Swan_soundbar_sound_leackage Defect

ALT Co., Ltd.

Issued Date 2021.05.11

Ver.1.0

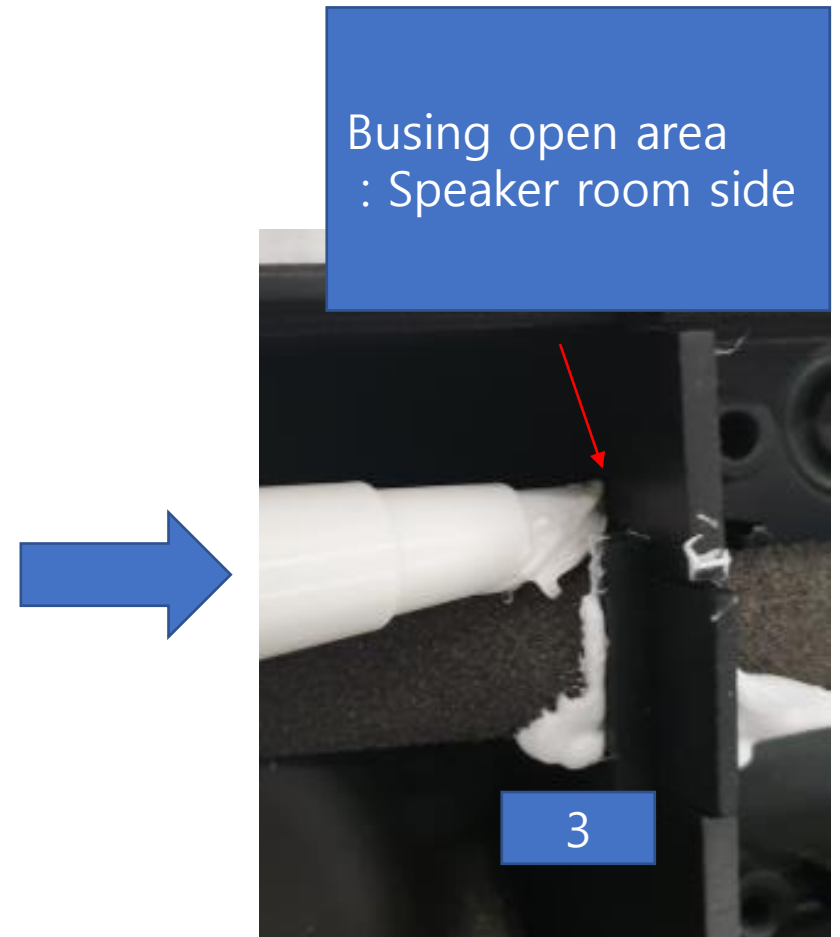
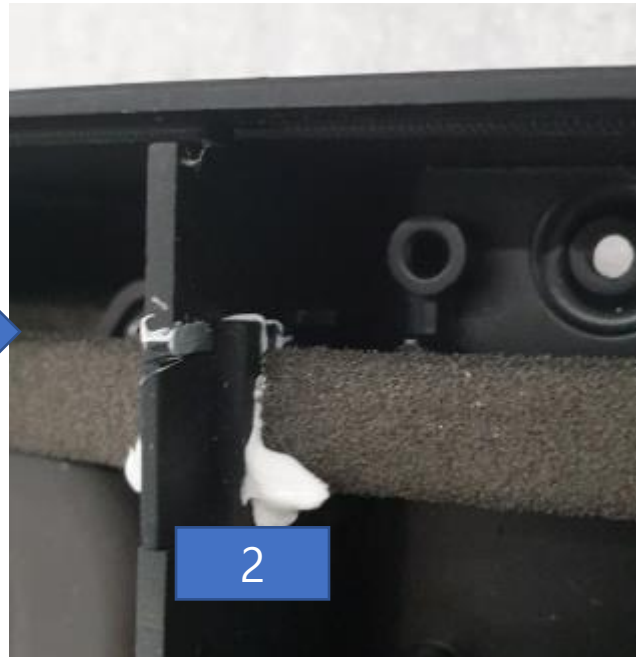
- Some of samples are leaking air due to DVT3 assembly quality
- FII has role of assemble according to the assembly guide, Check that assembly is correct.
- ALT is request air leakage test.
- Please make test solution and let's discuss

- Air leakage test guide
 - Play 50Hz sinewave. Max volume
 - Make reference sound recording file
 - Example sound :
<https://drive.google.com/file/d/1IlrkKzU8Su9SaS01Hc739a4pnBA55Jba/view?usp=sharing>
 - only hear 50hz sound.
 - Make defect sound below case
 - Example sound :
https://drive.google.com/file/d/1uZLIY1OWCF6ecD1swkH5ToI_vh5IbW_5/view?usp=sharing
 - hear 50hz sound and other frequency sound
 - Top gasket assembly defect
 - Inner bushing defect : Assembly or material
 - Inner gasket assembly defect
 - Bottom screw missing
- Compare and validation between reference sound and mass production sound

- Gasket attachment defect

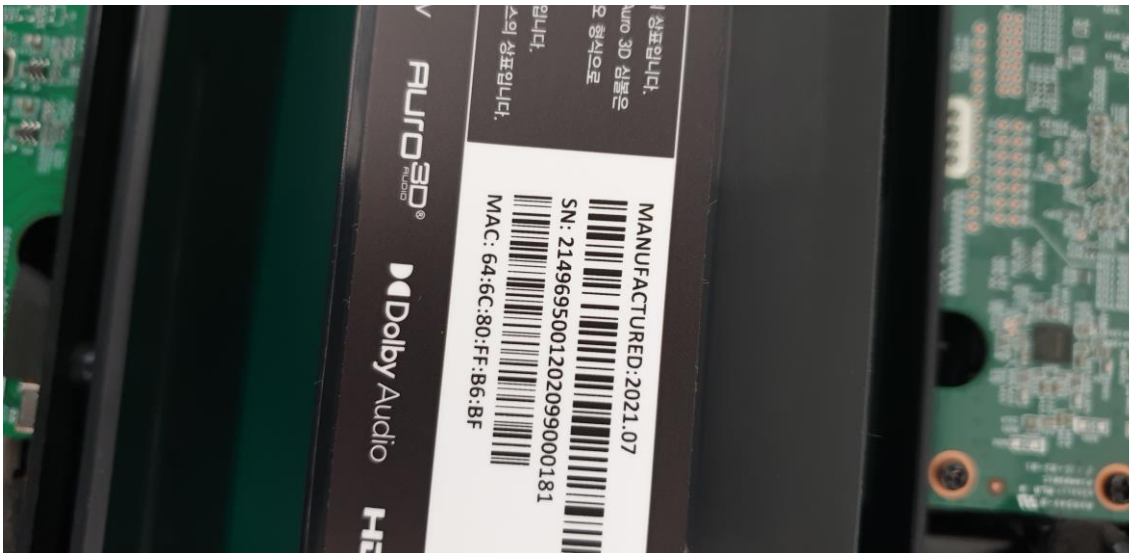
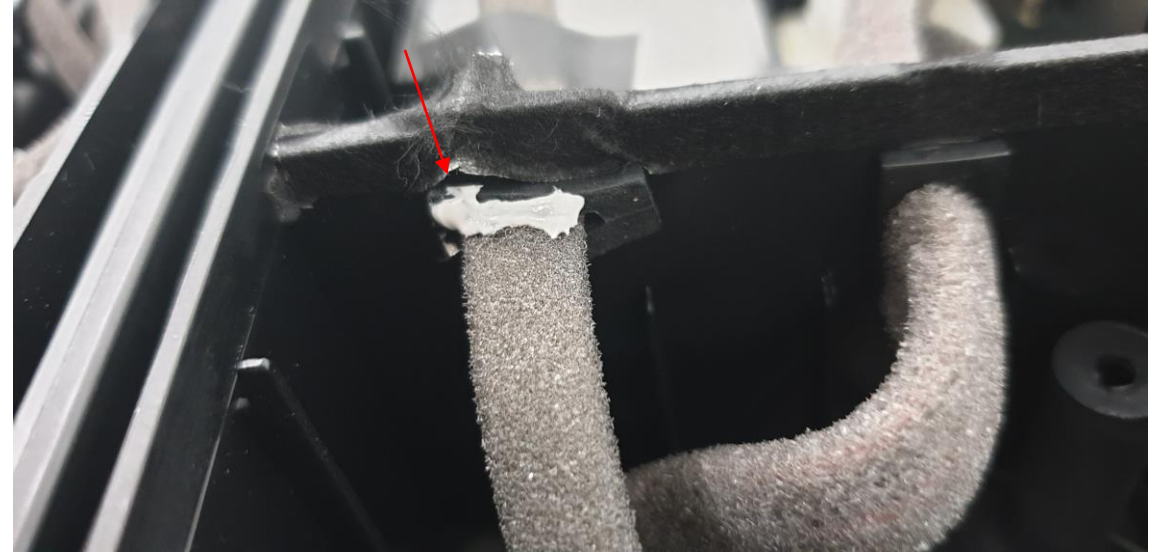
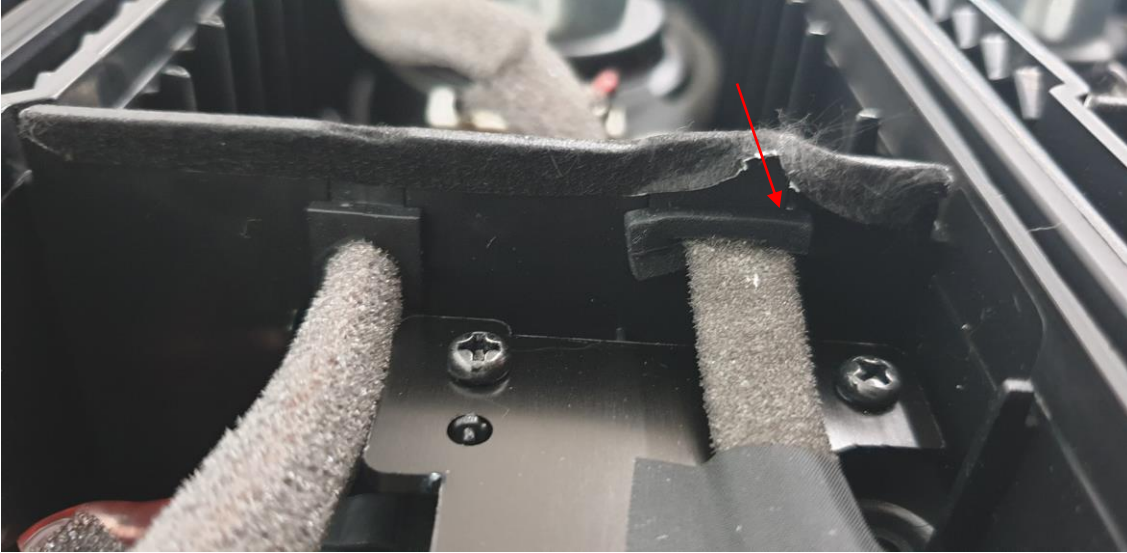
Gasket attachment line
The air leakage in this area

- Gasket attachment defect

Bushing defect – assembly or material

Missing inner gasket
